III. Revisions, Clarifications, and Corrections to the Draft EIR

This section of the Final EIR provides changes to the Draft EIR that have been made to revise, clarify, or correct the environmental impact analysis for the 2045 Violet Street Project (the Project). Such changes are a result of public and agency comments received in response to the Draft EIR and/or additional information that has become available since publication of the Draft EIR. The changes described in this section do not result in the Project creating any new or increased significant environmental impacts.

Revised Figure II-3
Conceptual Site Plan

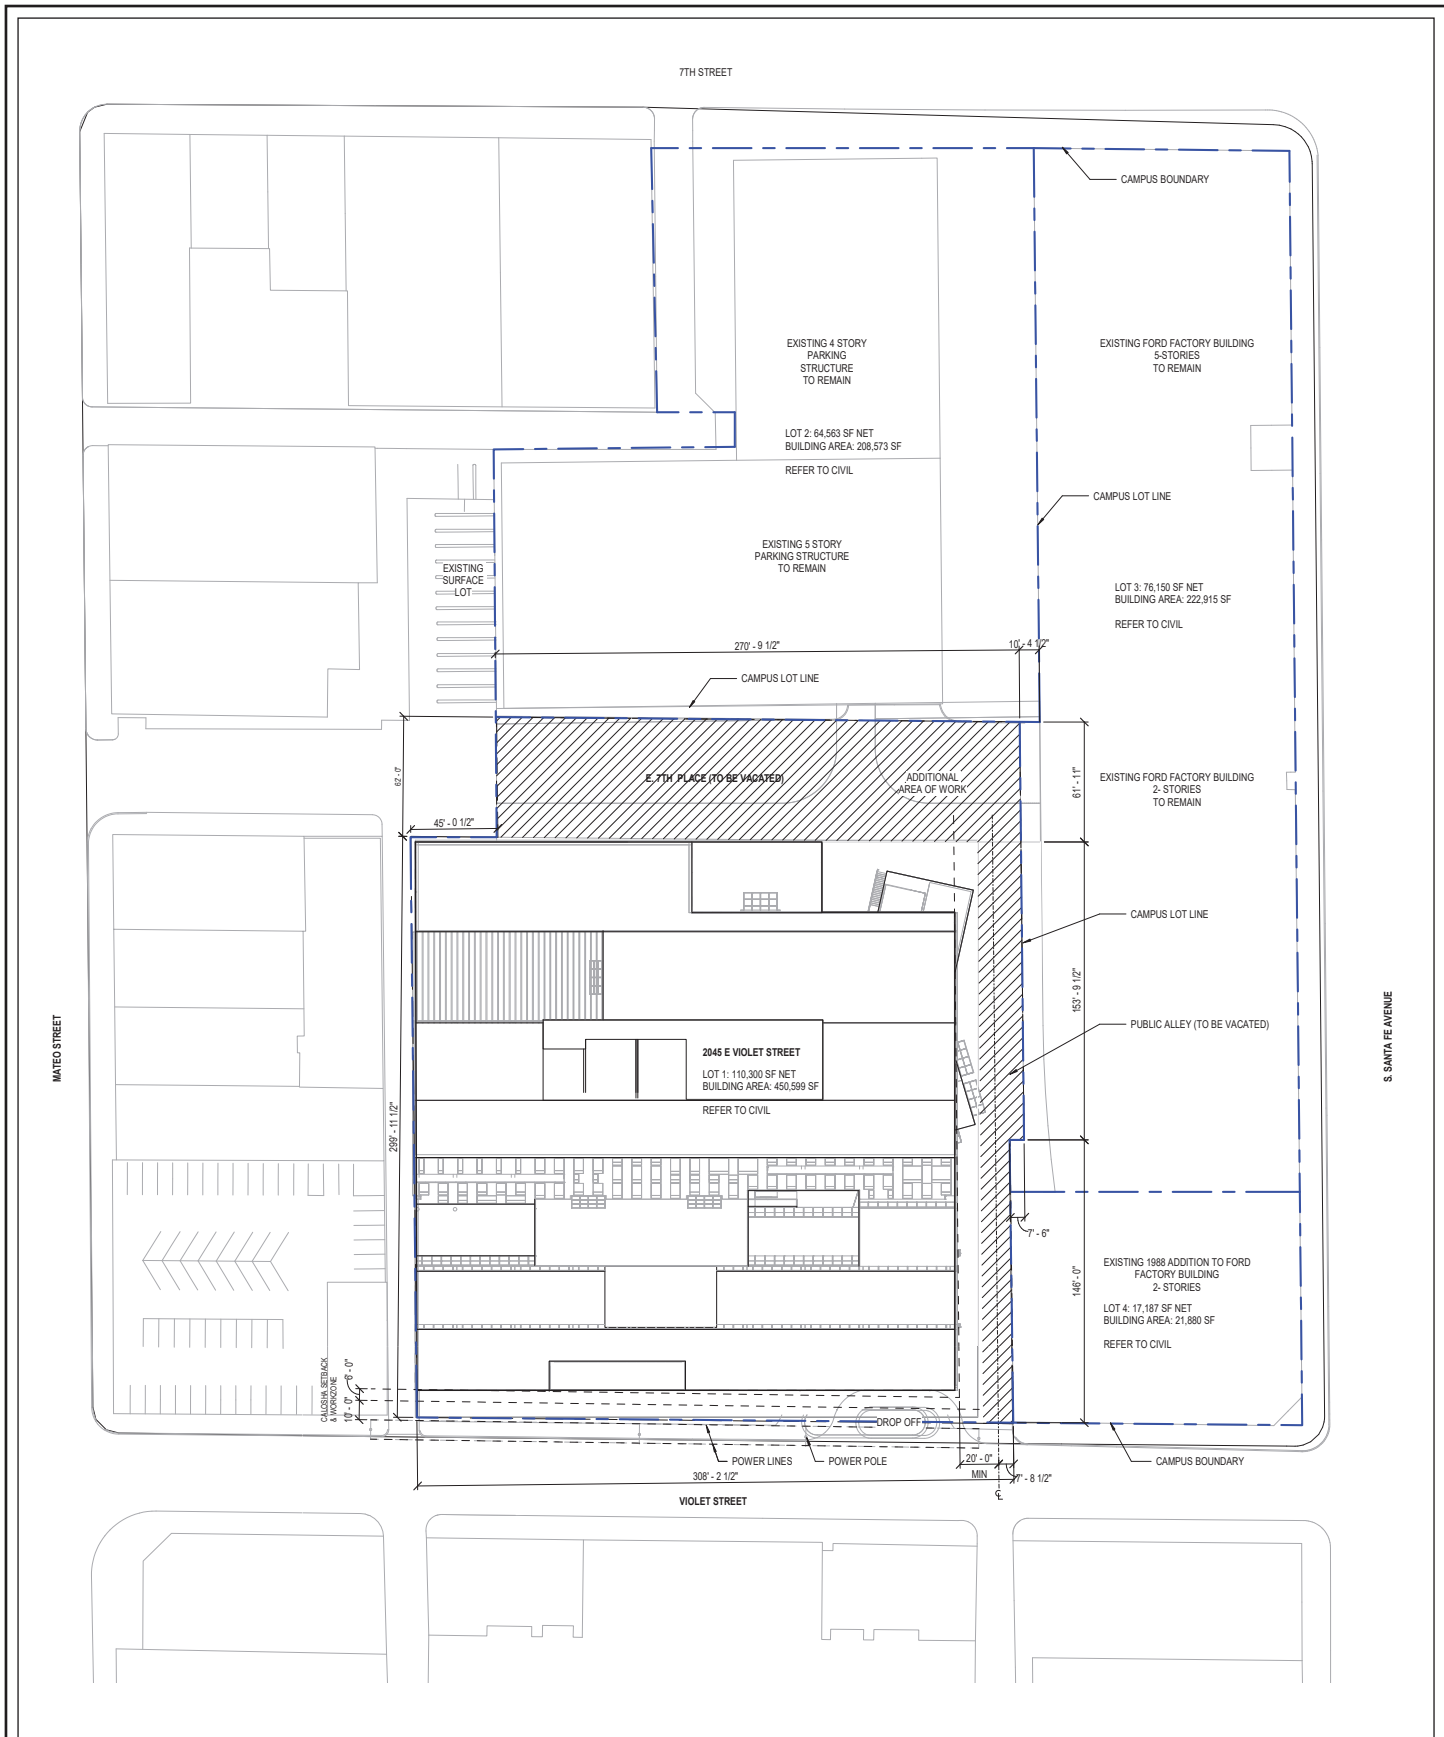
Section II, Project Description, page II-9, replace Figure II-3 with Revised Figure II-3 on page III-7.

Revised Figure II-5
Lot Line Diagram

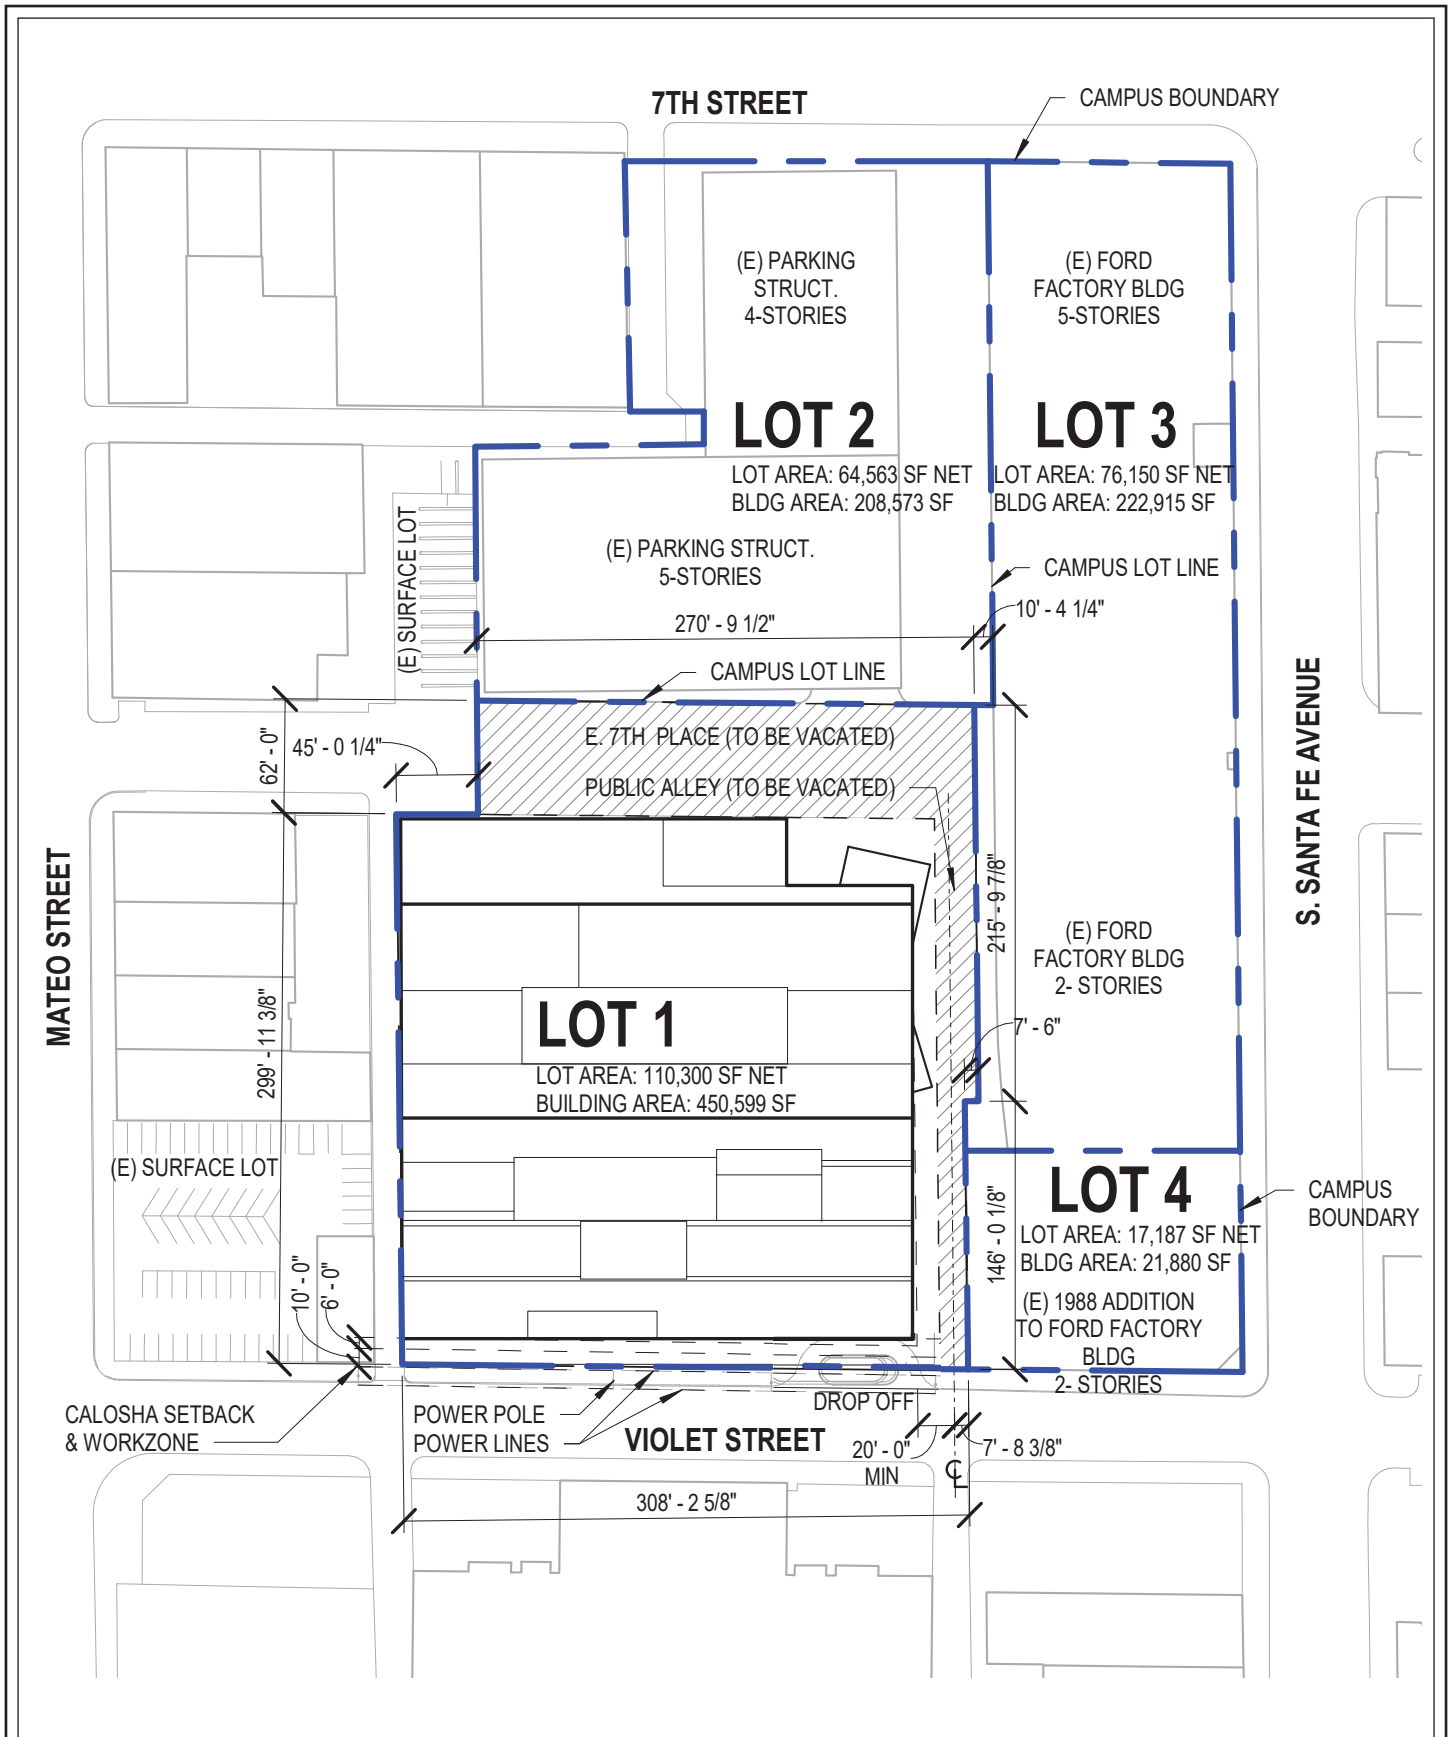
Section II, Project Description, page II-12, replace Figure II-5 with Revised Figure II-5 on page III-9.
